**Appl. No.** : **09/847,759**  
**Filed** : **May 2, 2001**

### REMARKS

In response to the Office Action dated February 18, 2009, Applicant respectfully requests reconsideration of the above identified application in view of the above amendments and the following comments.

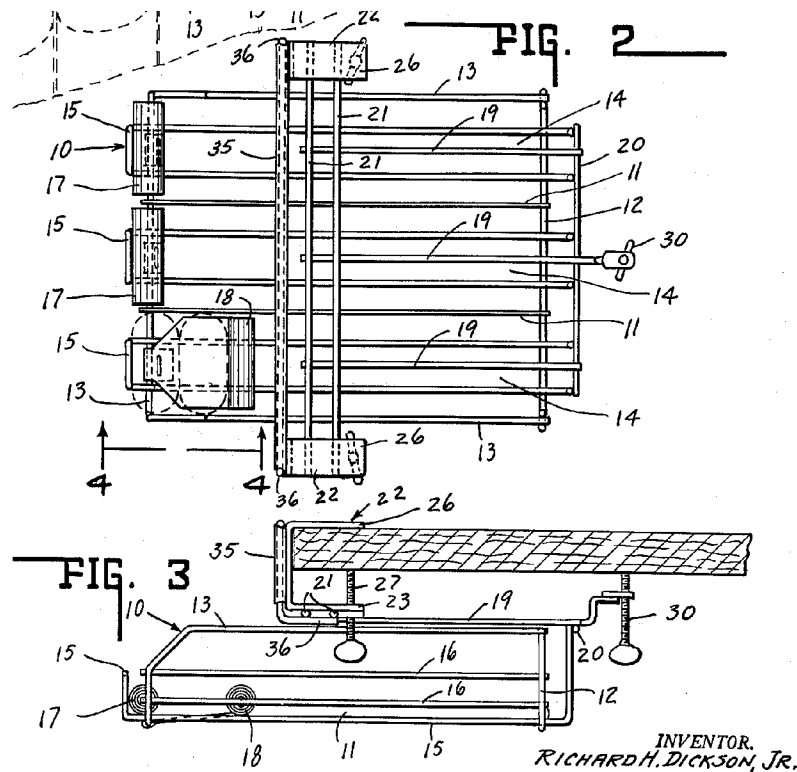
With regard to the rejection of Claim 56, Applicant would like to point out that Dickson teaches a shelf having a clamp extending across the front edge of a shelf and thumb screws 27 provided for clamping the shelving unit to another shelf above it.

As shown in the reproduction of Figures 2 and 3 from Dickson, set forth below, Dickson teaches using two cross members 21 extending across about the center of the shelf. These two cross members 21 are clamped to a shelf 32 disposed directly above the shelf unit. However, the shelving unit of Dickson does not provide a support frame with at least three cross members extending in a plane.

This is because Dickson does not disclose nor would one of ordinary skill in the art recognize that the Dickson shelf it could support an additional shelf above it in any stable manner. Rather, the two cross members 21, which may be considered as defining a plane, extend out about the center of the shelf.

At the rear of the shelving unit, a raised extended piece holds a further thumb screw 30. This thumb screw 30 does not provide a support for hanging the shelving unit from the shelf 32. Rather, the thumb screw 30 merely provides a manner by which the shelving unit can be tilted. For example, at column 2, lines 42-46, the Dickson reference indicates that “at the rearward end of the container there may be threadedly received a **further thumb screw 30** which as its threaded end projecting upwardly and may be used to adjust the position of the rearward end of the device with respect to the shelf.” (Emphasis added).

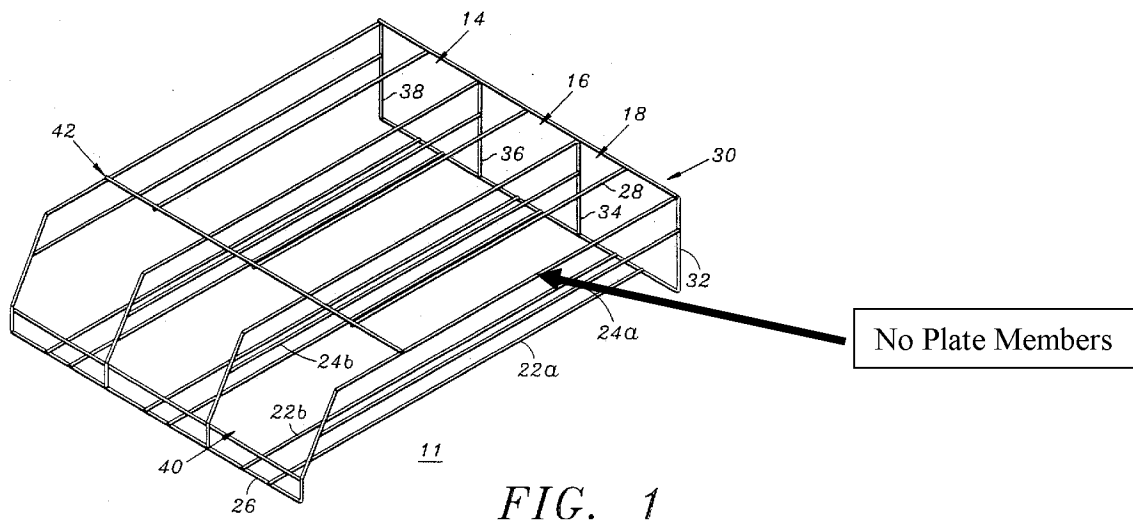
With regard to the rejection of Claim 1, Applicant would like to note that Buday teaches a storage cart that is designed to be supported on a rack that holds the cart in a tilted configuration. As noted in the reproduction of Figure 1 set forth below, Buday fails to teach a shelf structure having any plate members extending across the top whatsoever.

The Buday reference completely fails to teach any plate members whatsoever. Additionally, nothing in the Buday reference teaches or suggests that such a shelf structure could be configured for two modes of use, either supporting additional shelving above it or being hung from another shelf.
